Title - Sujet Contractor Access and Laydown Area	
Solicitation No. - N° de l'invitation EB144-181801/A	Amendment No. - N° modif. 003
Client Reference No. - N° de référence du client EB144-18-1801	Date 2017-11-24
GETS Reference No. - N° de référence de SEAG PW-\$PWA-121-5679	
File No. - N° de dossier PWA-7-78099 (121)	CCC No./N° CCC - FMS No./N° VME
Solicitation Closes - L'invitation prend fin at - à 02:00 PM on - le 2017-11-28	Time Zone Fuseau horaire Atlantic Standard Time AST
F.O.B. - F.A.B. Plant-Usine: <input type="checkbox"/> Destination: <input checked="" type="checkbox"/> Other-Autre: <input type="checkbox"/>	
Address Enquiries to: - Adresser toutes questions à: Russell (PWA), Alex	Buyer Id - Id de l'acheteur pwa121
Telephone No. - N° de téléphone (902) 401-8180 ()	FAX No. - N° de FAX (902) 496-5016
Destination - of Goods, Services, and Construction: Destination - des biens, services et construction:

Amendment 003 is raised for the following:**Questions and Answers****Question 1**

BURIED CONDUIT DETAIL (TYPICAL)

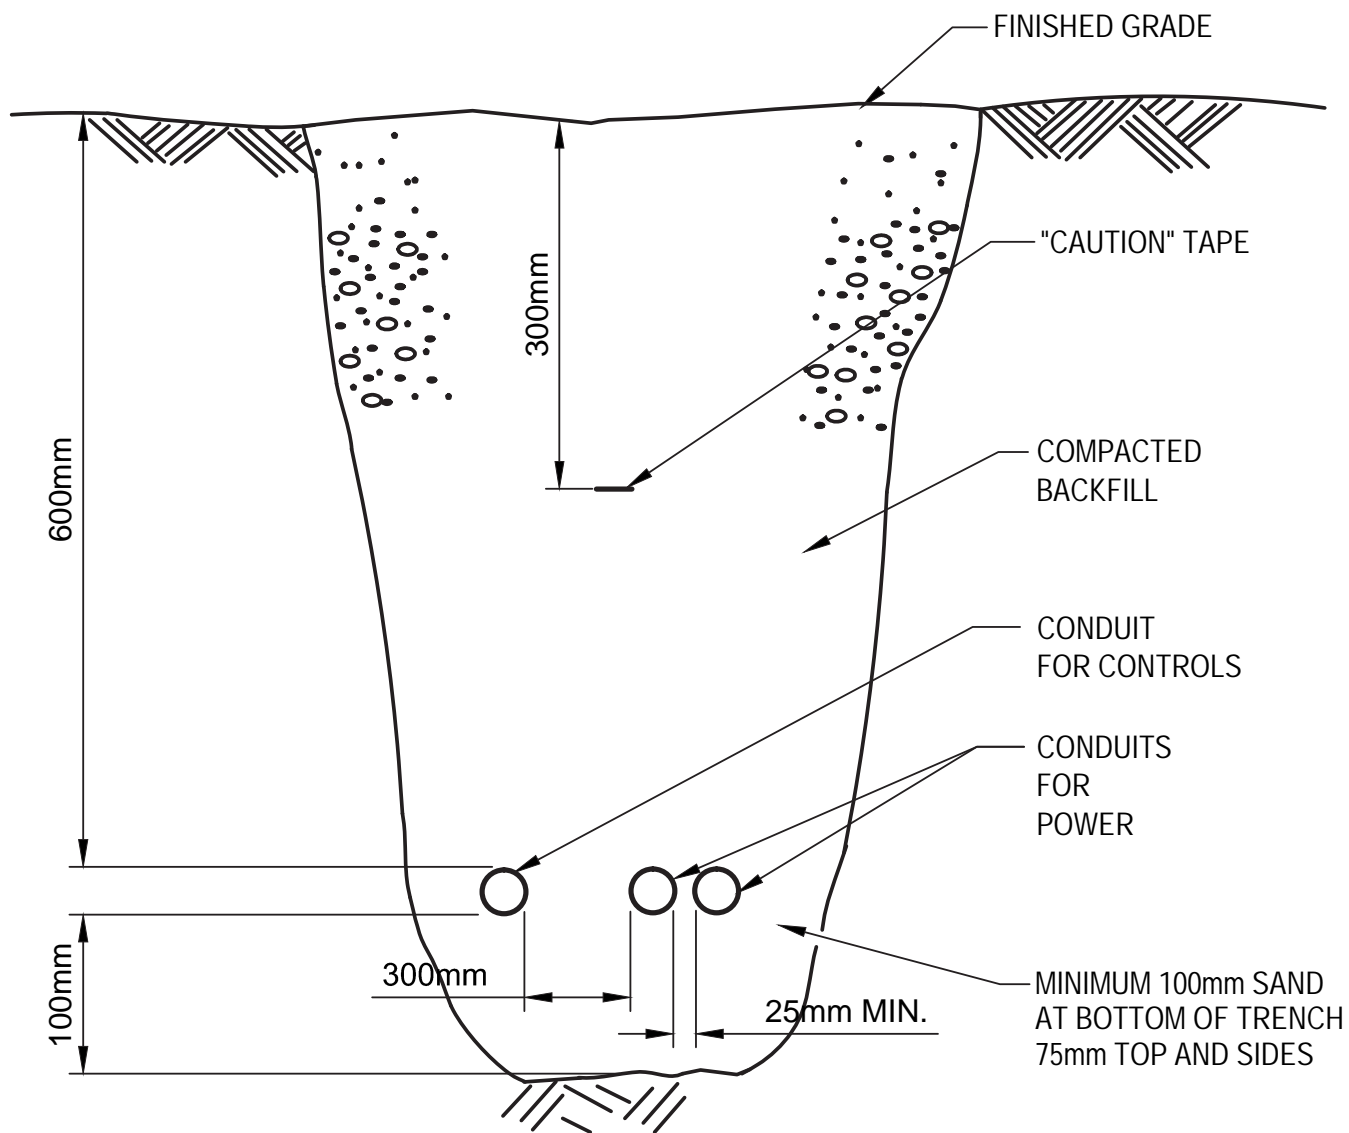
There is no detail on the electrical trenching. Will a detail be supplied?

See SK attached.

Note: The trench detail shown on the attached sketch is generic in nature and may be used as a guide to the requirements of trenches that will contain conduits to the 600V panelboard, the power centres and the poles. CEC Table 53 shall apply, and use in vehicular areas shall be assumed in all cases. The trenches shall be inspected by the authority having jurisdiction at various times during the construction, and its specifications may be varied by the authority having jurisdiction.
